## **HARWICH MAINTENANCE DREDGING FRAMEWORK 2018 TO 2021**

### **INFORMATION AND RESPONSES TO TENDER QUERIES: No: 1**

#### **DATE OF ISSUE: 2 June 2017**

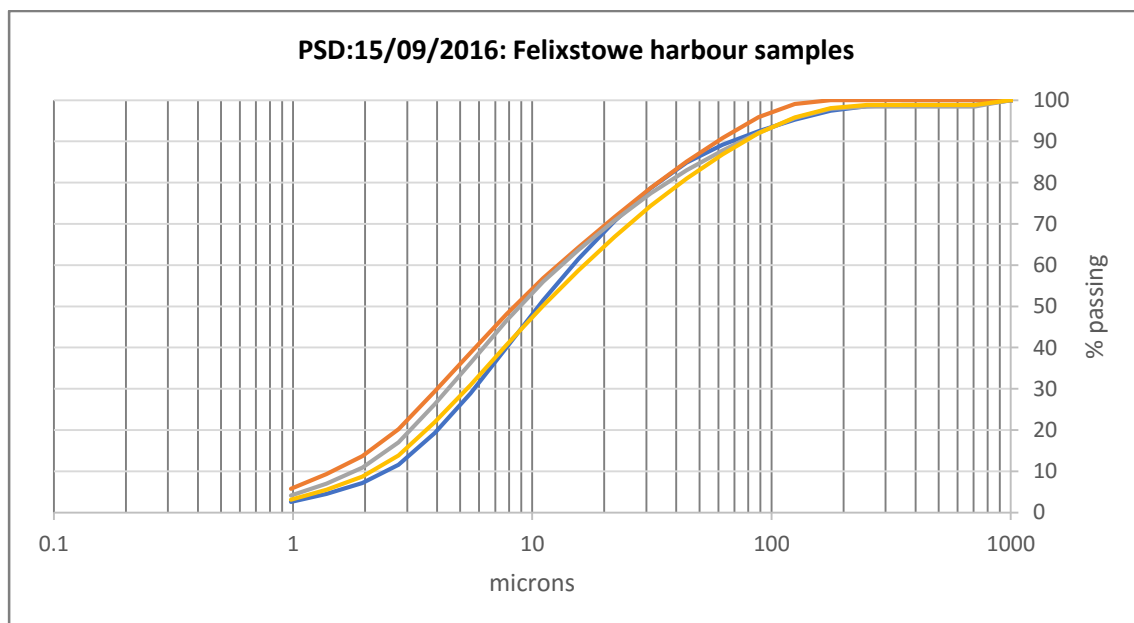
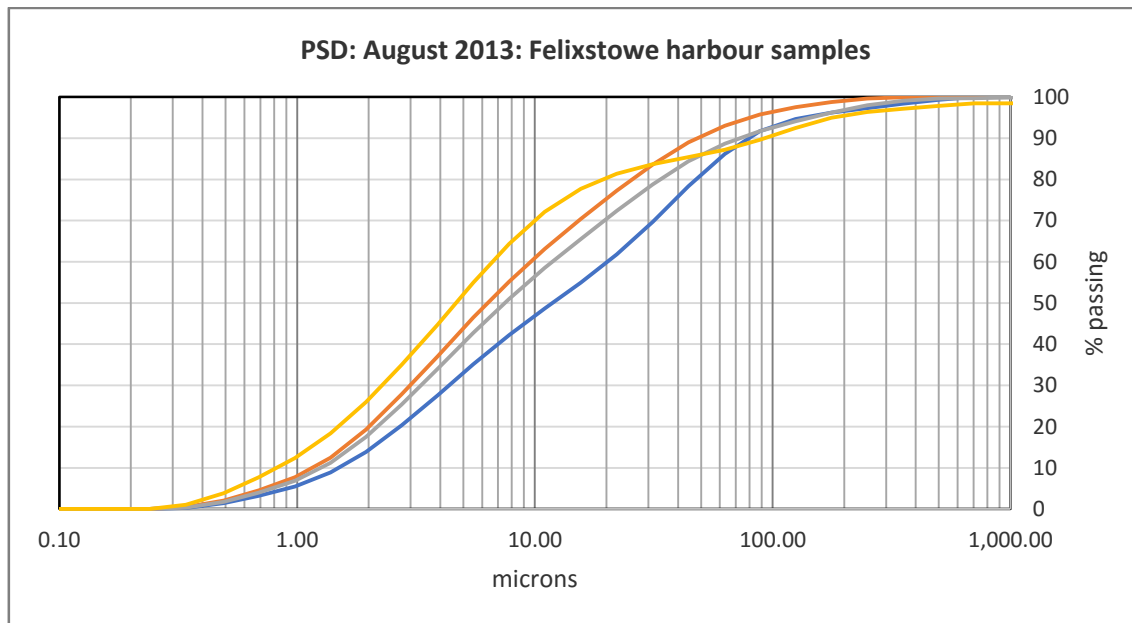
In clause 605.1, there is a reference to a particle size distribution of the material to be dredged and placed which should have been included in the documents. The PSDs below are those referred to in this clause. They were obtained in 2013 and 2016 and show the range of material to be expected. They also represent the material that will be dredged in Lot 1 and Lot 3 works.
